### **Amendments to the Drawings**

### **Annotated Marked-Up Drawing**

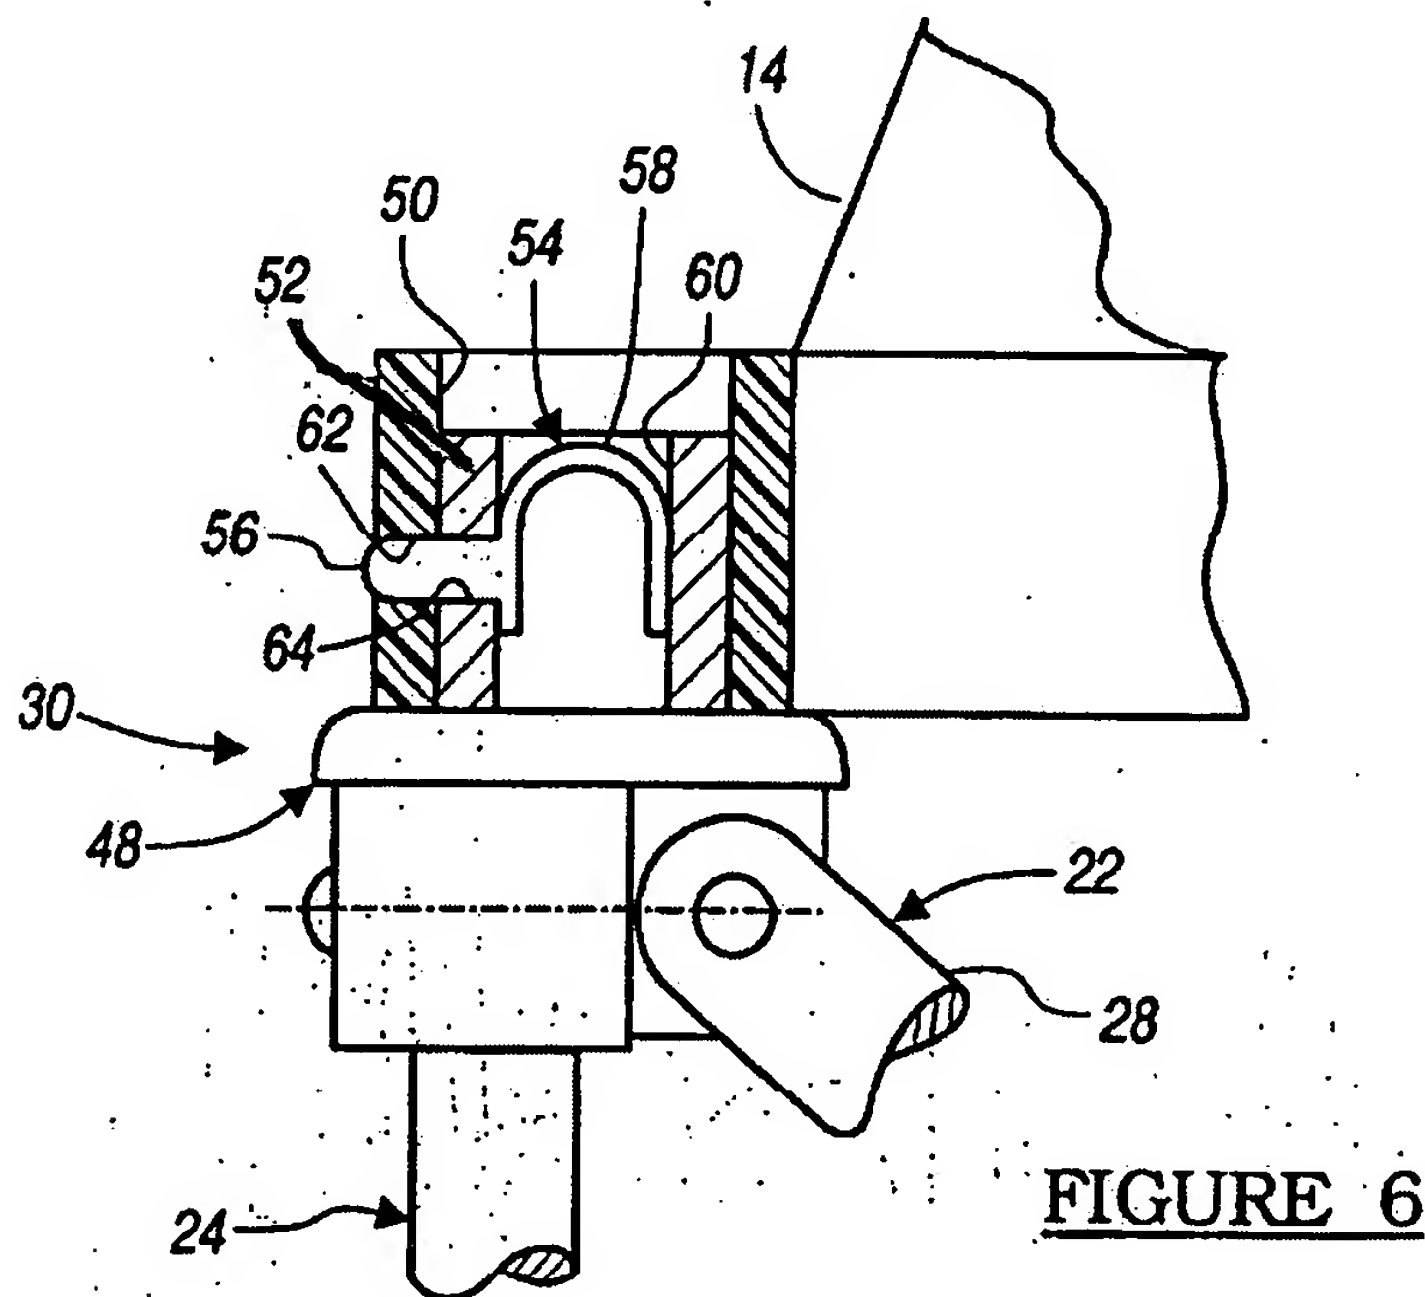
A replacement sheet of drawings including changes to Figure 6 is attached and an annotated copy of Figure 6 identifying changes made is included below. Specifically, Figure 6 has been amended to indicate the location of the pivot block projection 52 within the bore 50. Support for the amendments is found in the originally filed application. No new matter has been added. The Applicant believes that the objections to the drawings and the specification are now moot. Applicant respectfully requests that objections to the specification and drawings be withdrawn.
